**LEBANON PLANNING BOARD
DECEMBER 17, 2024 - 7:00 PM
COUNCIL CHAMBERS, CITY HALL OR
REMOTE VIA VIRTUAL PLATFORM
LEBANONNH.GOV/LIVE**

Re: The Brickyard Multi-family Planned Unit Residential Development (PURD)
174 Hanover Street Ext. & 238 Hanover Street (Map 48 Lots 1, 2, & 4 and Map 63 Lot 1)
Project Description and Impact Statement for Site Plan Review

Re: Proposed Multi-Family Development ("The Brickyard").
Site Plan Review Application
PUD/PURD Narrative Pieces

Drawing Title
**Existing Conditions
Plan of Land**

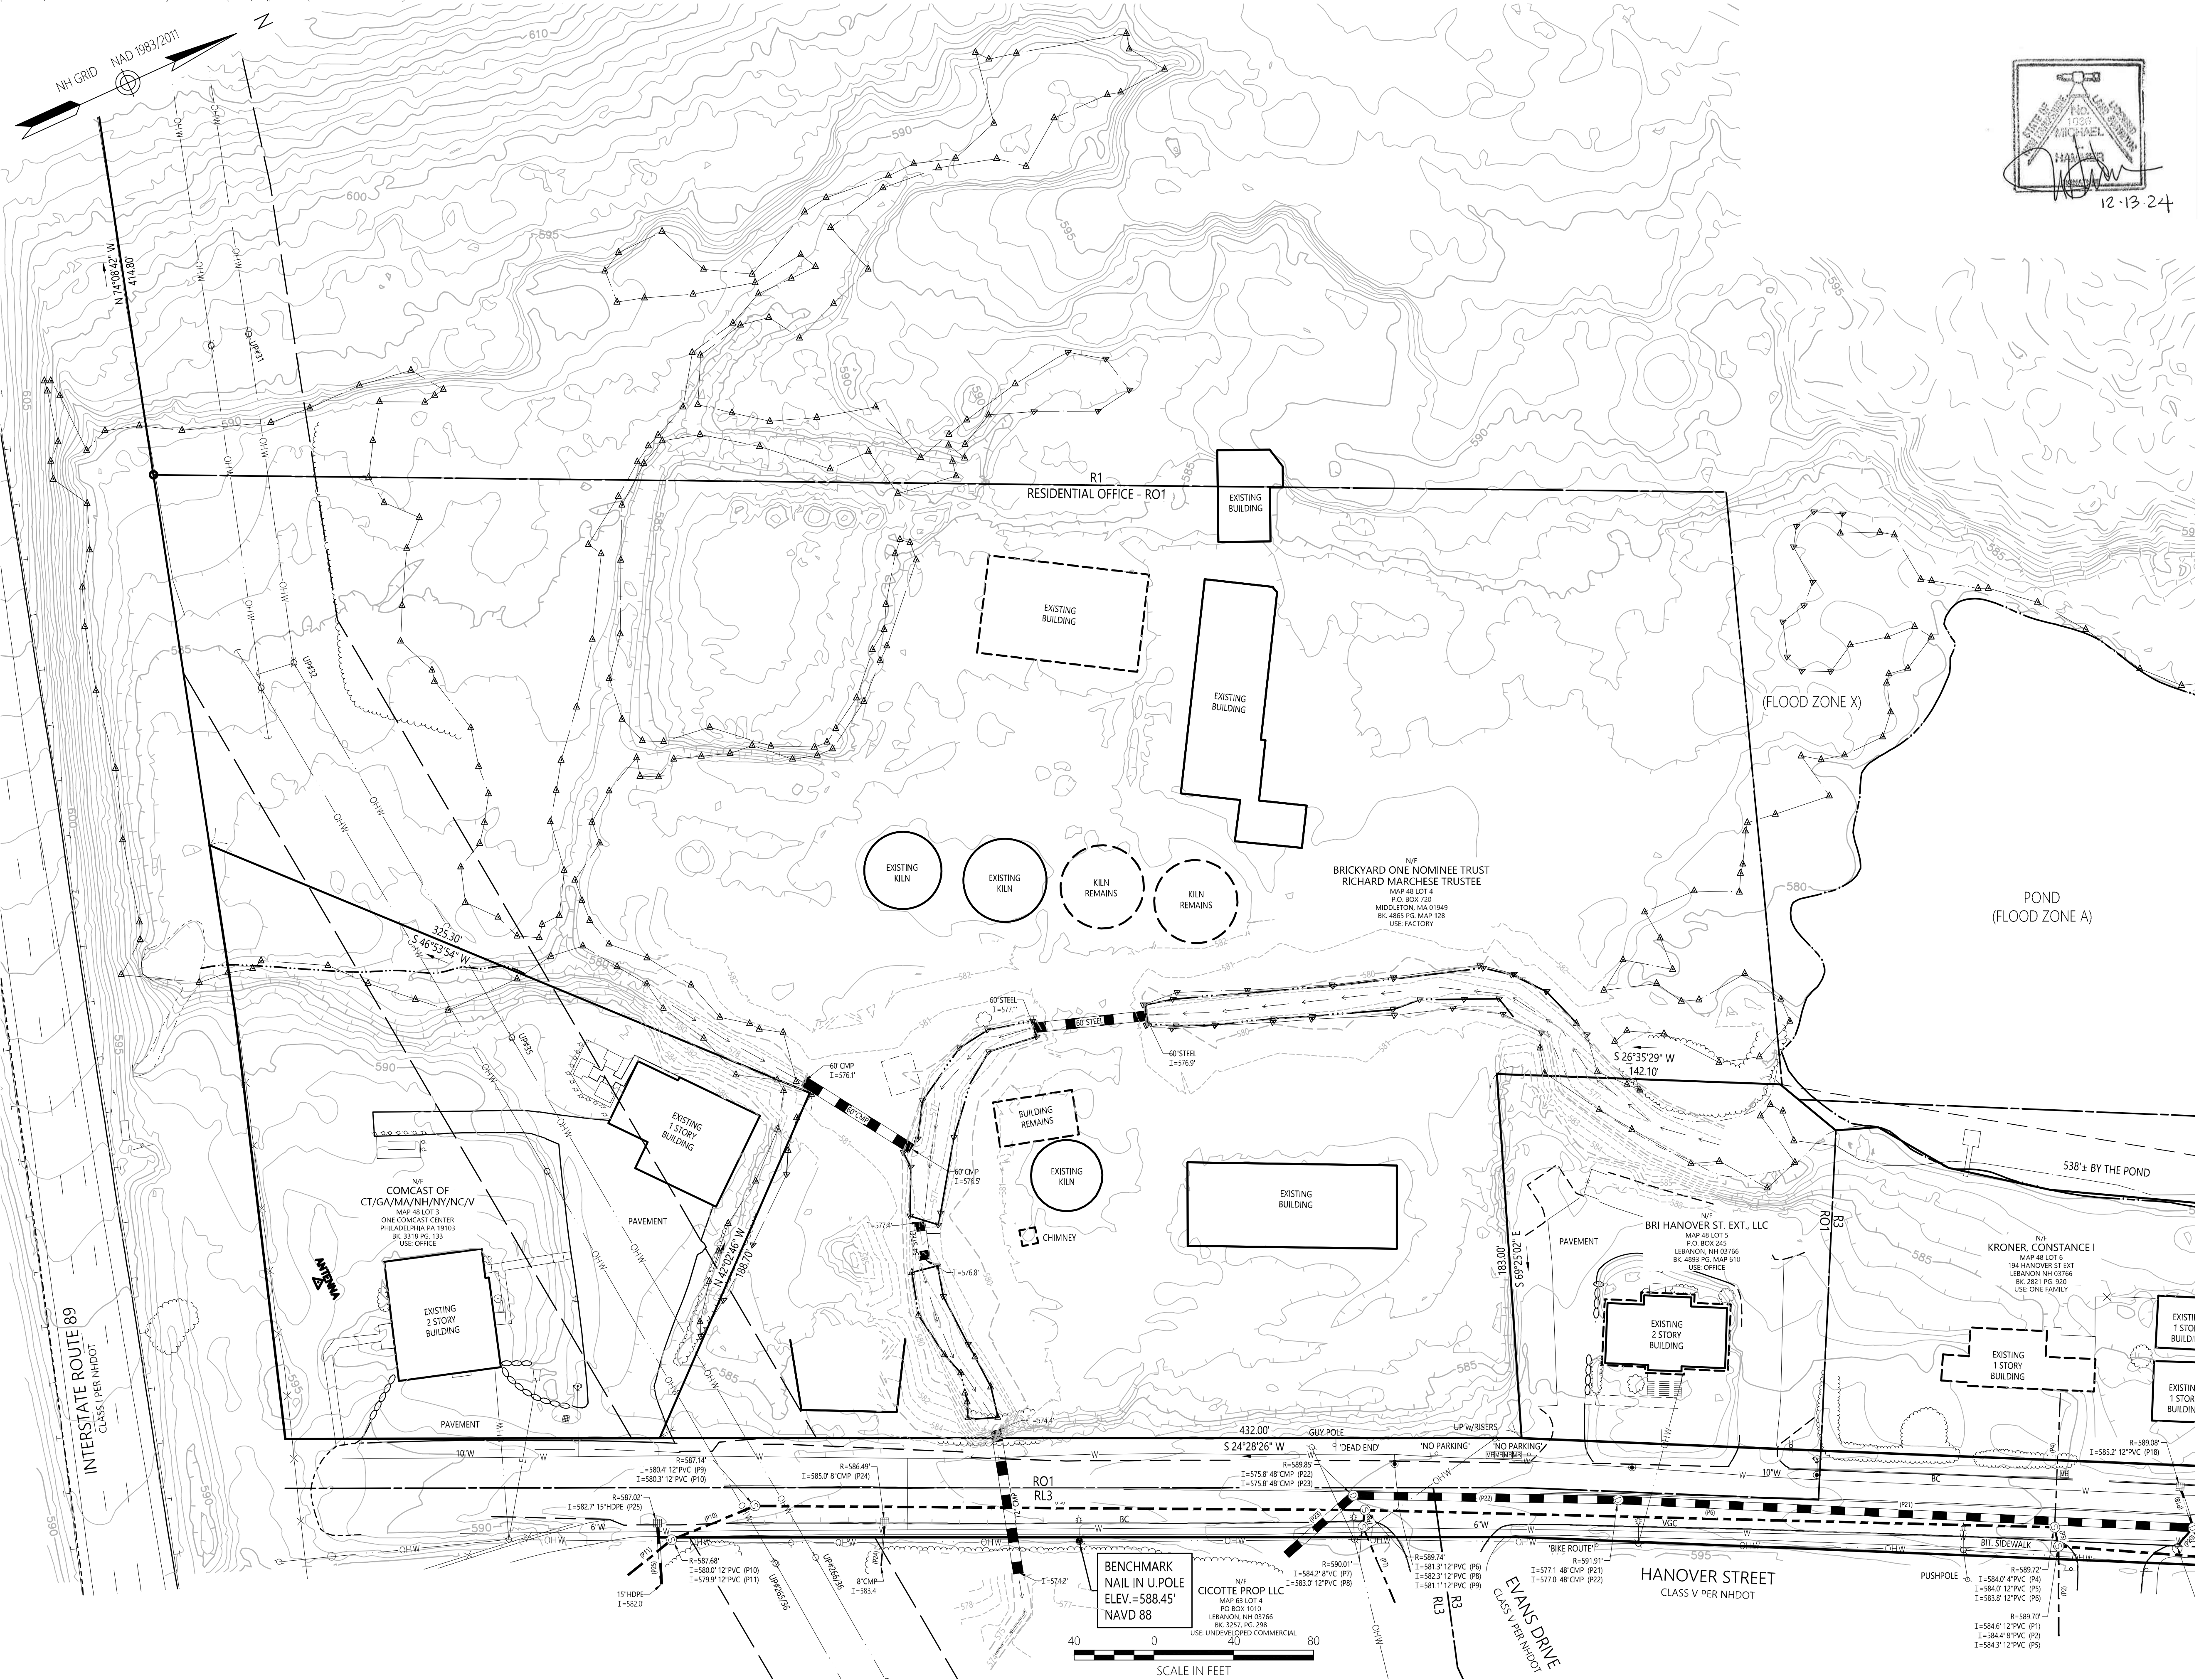
Comment 30. ***Sheet 43 (Sv-2)***

Response: A Site Demolition and Preparation Plan has been added to the set as sheet C1.4.

Response: A Site Demolition and Preparation Plan has been added to the set as sheet C1.4.

Response: The legend has been updated to property identify the noted line. See Sheet C1.0.
